From: [Ager, Ashley](#)
To: [Barr, Leigh P EMNRD](#)
Subject: [EXTERNAL] RE: Hilcorp Tank Mountain Landfarm
Date: Tuesday, October 19, 2021 10:08:17 AM
Attachments: [017818018 FIG10C TANK MOUNTAIN SEISMIC 2021.pdf](#)
[TANK MOUNTAIN MINES MMD-SearchResults-EPPlus.xls](#)
[017818018 FIG08 TANK MOUNTAIN MINE LOC 2020.pdf](#)
[Operations Schedule Updated 10-14-2021.pdf](#)

Thank you for the response. I have provided clarification below by listing your questions in italics with corresponding responses directly following each question.

FIGURE 8
PROXIMITY TO SUBSURFACE MINE
TANK MOUNTAIN LANDFARM
SESW SEC 5 T31N R9W
SAN JUAN COUNTY, NEW MEXICO
HILCORP ENERGY COMPANY

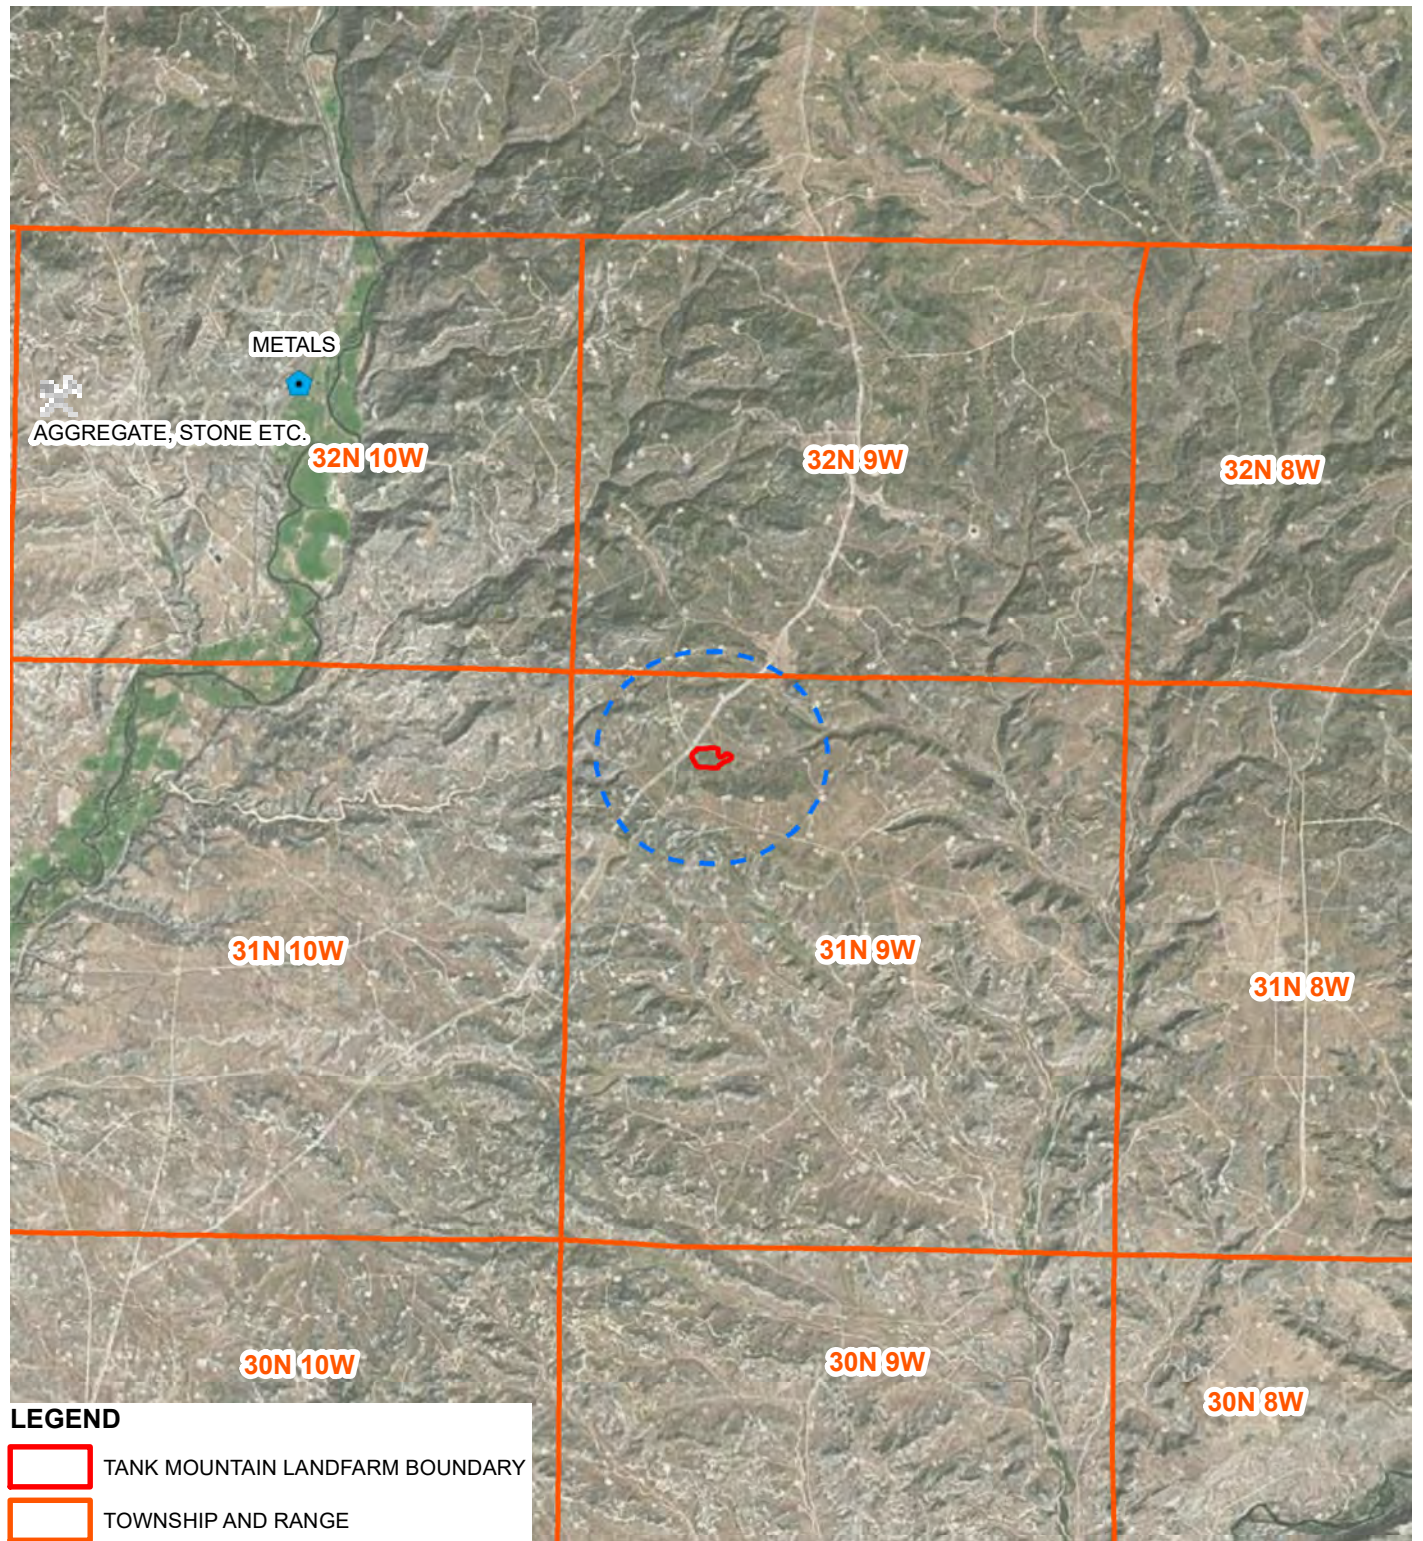
Hilcorp must provide OCD with their search results to demonstrate the landfarm is not within an area overlying a subsurface mine utilizing the following link:
<http://www.emnrd.state.nm.us/MMD/mmdonline.html> as recommended by Mike Thompson.
Please see the attached MSEXcel file (TANK MOUNTAIN_MINES_MMD-SearchResults-EPPlus.xls) that

correlates to Figure 8 in the application (and attached again here) showing search results for mines in the area. The closest facilities identified in the search results are mapped on Figure 8.
